DESCRIPTIVE REPORT
(HYDROGRAPHIC)

Type of Survey HYDROGRAPHIC
Field No. SU-10-1-57
Office No. H-8963

State ALASKA
General Locality COOK INLET
Locality REDOUBT BAY

OFFICE OF MARINE SURVEYS AND MAPS
MARINE SURVEYS DIVISION
MODIFIED HYDROGRAPHIC SURVEY REVIEW

Diagram of DRIFT RIVER MARINE TERMINAL

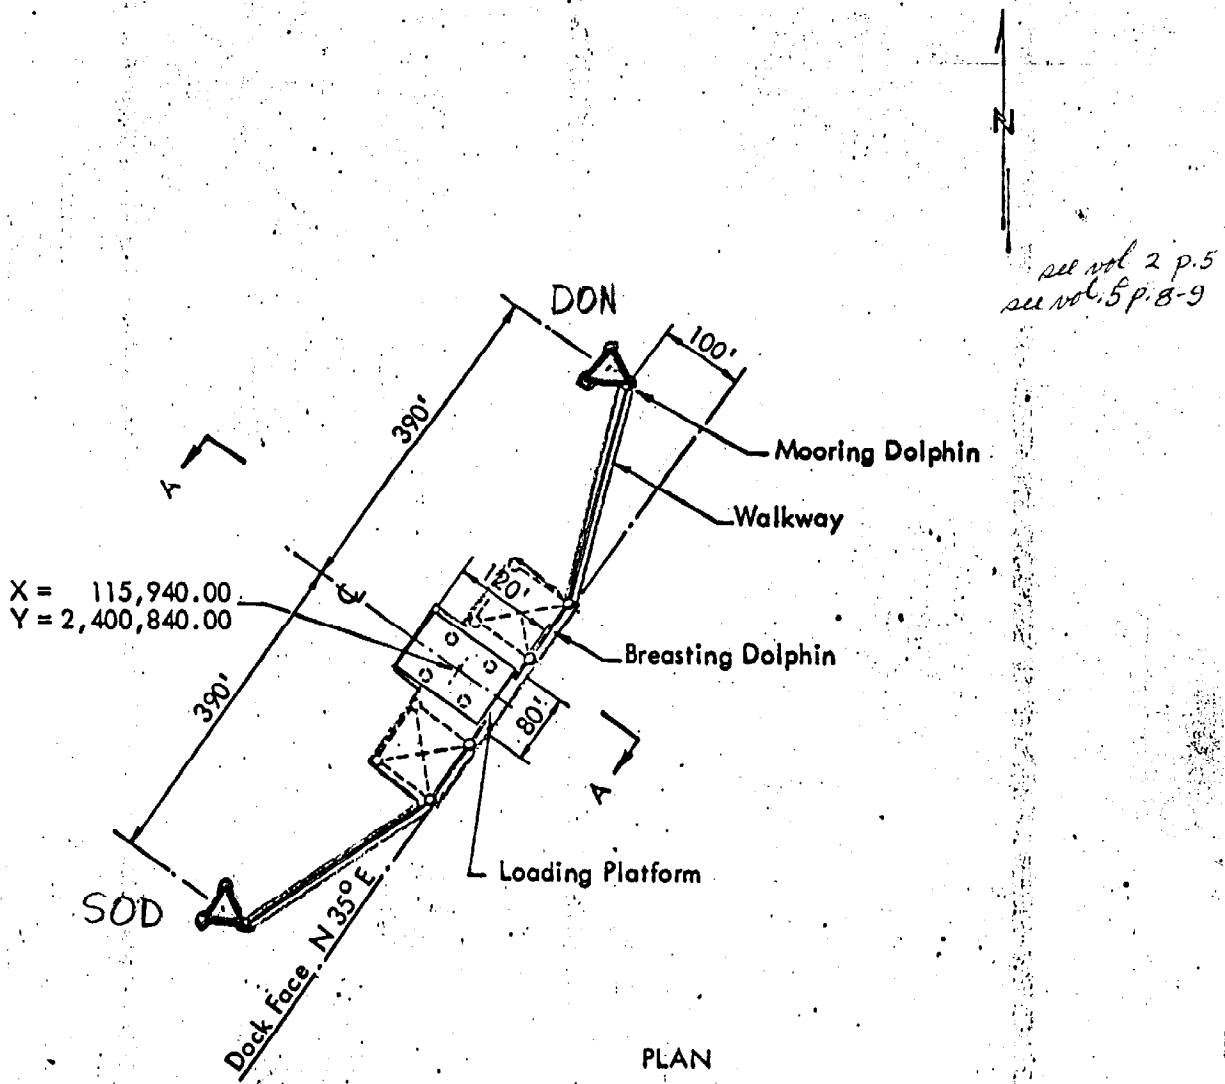
see Review par. 3a & 6a

- d. The 1:1,000-scale inset in the vicinity of latitude $60^{\circ}32.2'$, longitude $152^{\circ}08.0'$ submitted as part of the present survey could not be fully utilized. This large-scale inset comprised the work of Launch 4 on August 28, 1967, in the location of the 12 platform legs of the incomplete Drift River Marine Terminal (Presurvey Review Item No. 29) and adjacent depths. The control used on the inset was weak and unreliable and therefore rejected. The positions of the platform legs as shown on the inset differed from those using the sextant fixes recorded in volume 5. However, several depths were retained to supplement existing hydrography. The present delineation of the bottom in the area is adequate.
